RE: Staff Recommendations 05/15/12

HPC 12.041 -- 47 Columbus Avenue - 1882 Philip Eberle House

Applicants: Dominique Stassart & David Dinklage, Owners

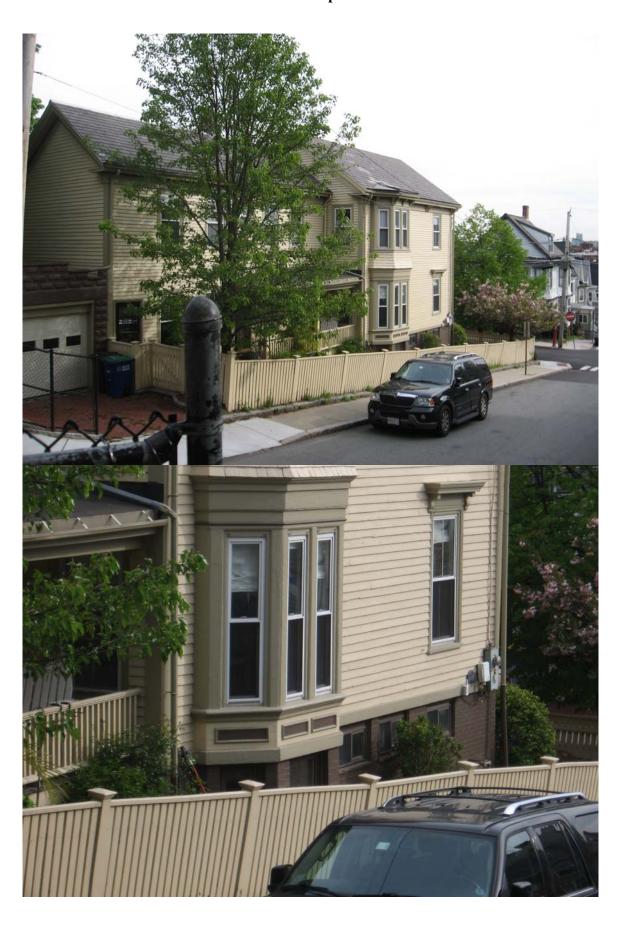
These are the original openings on the Philip Eberle house. Basement windows are generally small since they were not intended to let in a lot of light but to provide ventilation. The proposed alterations are those needed to add living space to the house and do not meet the above Guidelines. However, the General Guidelines note that changes do occur over time and can acquire significance; that sometimes change is necessary and that so long as the alteration does not negatively impact the historic fabric, it may be allowed.

The installation of a second full-sized door on the main façade would indicate a major change in the perception of the house. This was a bulkhead and basement access point. A door here would give it prominence that takes away from the main entry especially with additional landscaping and grading and the give it more prominence than it should have.

Enlarging the basement windows in the main block of the house also gives them more prominence. Staff does **not recommend** granting a **Certificate of Appropriateness** for either of these proposed changes and therefore is not going to discuss either the proposed window style or material or the proposed door details.
